Appendix C:

Transcribed and Categorized Comments from Public Outreach

Re: WMATA Mass Transit Plan Amendment – Greenbelt Metrorail Station

Figure 1: Greenbelt Site DEIS Concept Plan Recommendations

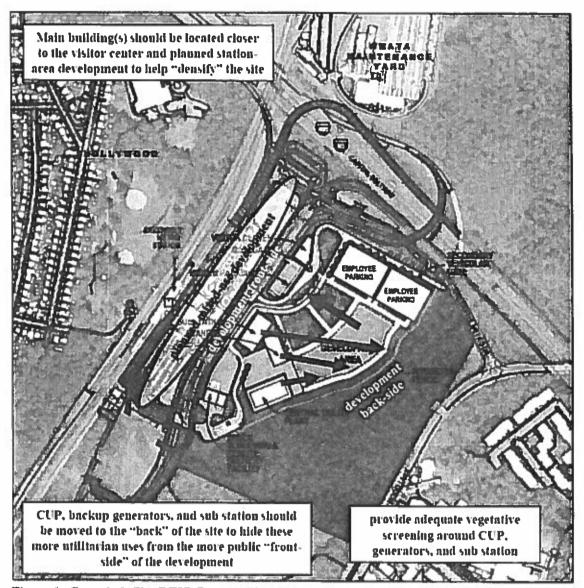
As shown in Figure 1, the main administrative building(s) could be situated closer to the Metrorail station and visitor center to create a more compact, pedestrian-friendly development, which is more compatible with the planned Greenbelt station-area development located to the west. In contrast, the DEIS concept shows a front lawn between the "development area" and station, which suggests a more suburban-style campus, with a main building set back and longer walking distances for pedestrians. The central utility plant, substation, and standby generators could then be shifted to the rear of the campus, between the main building(s) and existing parkland. This location would allow the main building and parkland to screen those more functional elements. Further, locating these more utilitarian uses toward the rear of the campus would help hide the

structures from the planned station area development, visitor center, and "front door" of the campus. This revised layout would better integrate the proposed FBI campus with the station development, and provide an improved pedestrian experience for visitors and employees.

Figure 2: Landover Site DEIS Concept Plan Recommendations

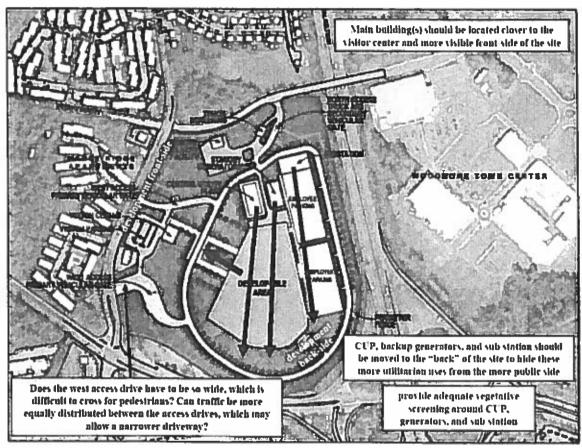
Similar to the Greenbelt plan, consider the orientation and massing of the main development area on the Landover site (Figure 2) to the campus's "front-side" (along Brightseat Road and Evarts Street) to increase the visual presence of the central offices and minimize the travel distance between the visitor center and main building(s). The utilitarian uses (central utility plant and standby generators) should be shifted to the campus's less-visible, "rear" area, adjacent to the highway off-ramp, near natural/vegetative screening. The adjusted development configuration would create a more pleasant urban design quality for the campus and highlight the buildings (main headquarters and visitor center) in a more appropriate manner. In addition, other plan features should continue to be refined such as the West Access primary vehicle gate, which appears too wide for pedestrians to comfortably cross at the intersection of Brightseat Road.

Figure 3: Springfield Site DEIS Concept Plan Recommendations

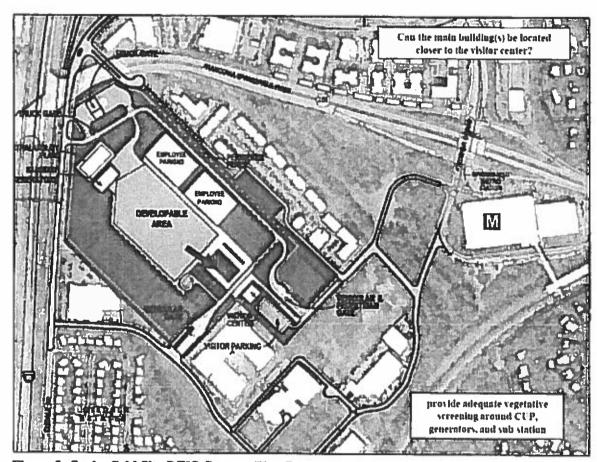
The Springfield concept (Figure 3) shows a development configuration that appears to be more appropriate to its surrounding context compared to the Greenbelt and Landover concepts.

However, the development team should consider moving the main building development area closer to the visitor center/lot to reduce the walking distance. Such a move would also allow more distance between the truck inspection area and main headquarters building. In addition, the site is located immediately adjacent to low-scale residential uses to the northeast. The proposed parking garages could be moved to the southwest-side of the site to allow for a more appropriate transition and buffer between the campus and adjacent apartments.
